# 8960DEC

NTSC/PAL to 4:2:2 Adaptive Decoder

Release Notes

SOFTWARE VERSION 5.0

Figure 4. 8960DEC Video Processing Display

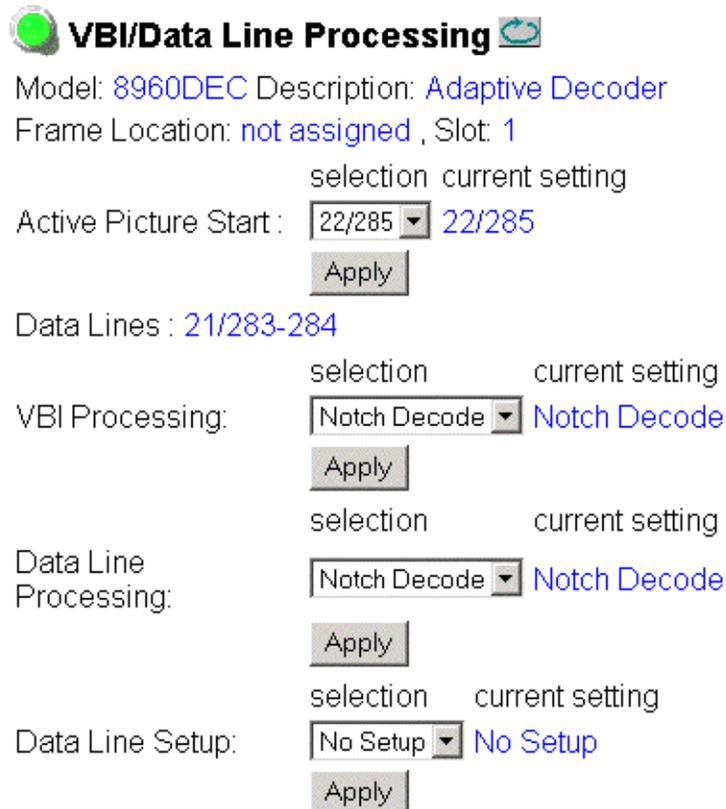
To set the parameters through the browser, use the VBI/Data Processing web page display shown in [Figure 4](#) to:

- Choose the line number for the start of active picture (SAV) from the **Active Picture Start** pulldown selections. The available data lines will be displayed.
- Set **VBI Processing** to **Delete**, **Notch Decode** (low and band pass filtering), or **Video to Luma** (no filtering).
- Set the Data Line Processing pulldown to either **Notch Decode** (U and V channels blanked) or **Delete** (remove content), and
- In 525 line standard, set Data Line Setup pulldown to **Setup** or **No Setup** to indicate if setup is present on data lines.
